**REGIONAL SAFETY RECALLS 13V-547, 12V-306 AND 10V-436
BULLETIN UPDATE ANNOUNCEMENT**

This letter and specific bulletin sections are being sent to you to notify you of bulletin updates for Safety Recalls 13V-547, 12V-306 and 10V-436 – Corrosion Affecting the Forward Mounting Point for Rear Suspension Lower Link Brackets on certain Isuzu passenger vehicles.

PROCEDURE INFORMATION UPDATE – ALL BULLETINS

Figure 2 – Step 2 Hammering Locations

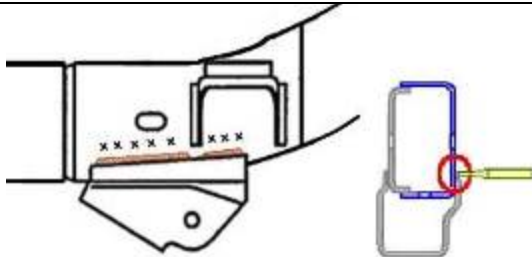
2. Using a 3/16" flat punch and a 12-16 oz. hammer, hammer on the locations identified with an "X" in Figure 2. Swing the hammer 10 to 12 inches to be sure enough force is applied to the punch. If a hole is created go to Step 4. If no hole is created, visually inspect the Rear Lower Trailing Link Front Mounting Bracket inspection area. Use the Visual Comparison Photo (P/N 2-90SVA-003-0) or Figure 1 for reference. If most of the frame coating is still in place and very little surface rust is present, apply Noxudol 300 (Go to "Condition One: Apply Noxudol 300" in this bulletin). If most frame coating is missing and excessive rust is present go to the next step.

Figure 3 – Step 4 Hammering Locations

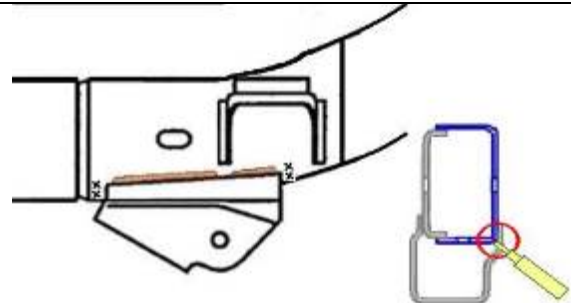
3. Apply Noxudol 700 and Noxudol 300 (Go to "Condition Two: Apply Noxudol 700 and Noxudol 300" in the appropriate bulletin).
4. Using a 3/16" flat punch and a 12-16 oz. hammer, hammer on the locations identified with an "X" in Figure 3.
 - a. If no hole is created, continue to Condition Three in the appropriate bulletin.
 - b. If the flat punch creates a hole in any one location, continue to Condition Four in the appropriate bulletin.
